ADDENDUM

STACKER-8 PN 7020

Multiple Spark Programming Loop.

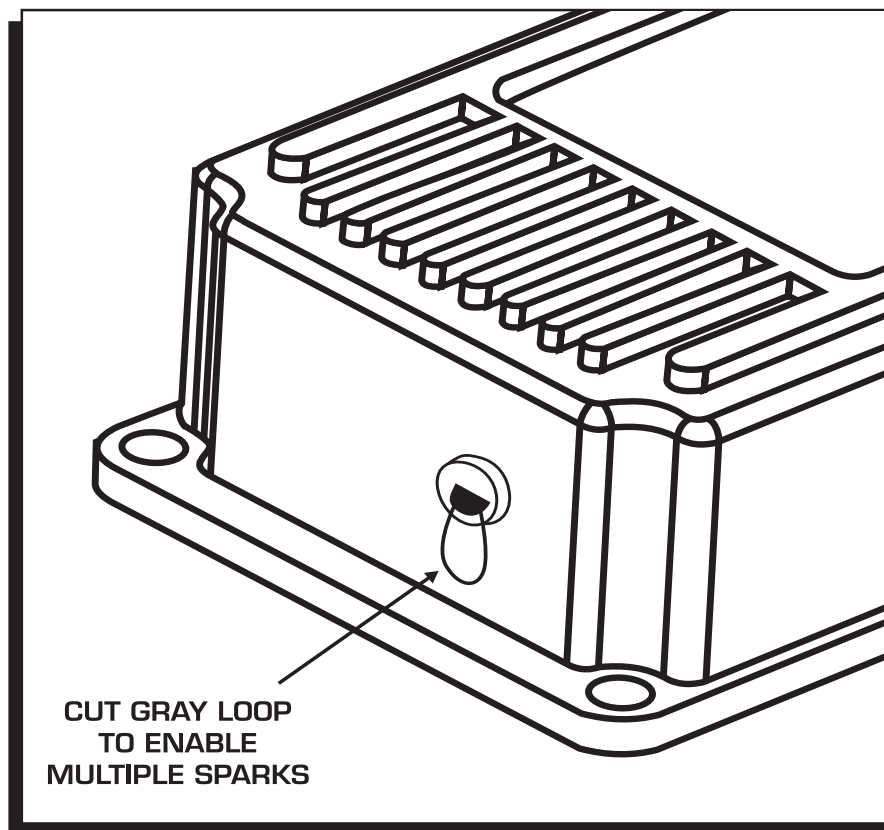
The Stacker-8 Ignition Control, PN 7020, now has a programming wire loop that controls its multiple sparks. The wire loop is accessible on the side of the case.

The Stacker-8 comes from MSD set for single spark operation. This is because in some applications (such as late model Fords), the factory ignition fires each coil multiple times. This results in a misfire with the Stacker as the two multiple sparks are not compatible and will cause a rough running situation.

In non-Ford applications that will accept the Stacker-8's multiple sparks, cut the Gray wire loop. This will enable the multiple sparks of the Stacker-8. Note that if your engine seems to miss or run rough, the Gray loop will need to be reconnected. This would indicate that your vehicle's factory ignition is a multiple spark design.
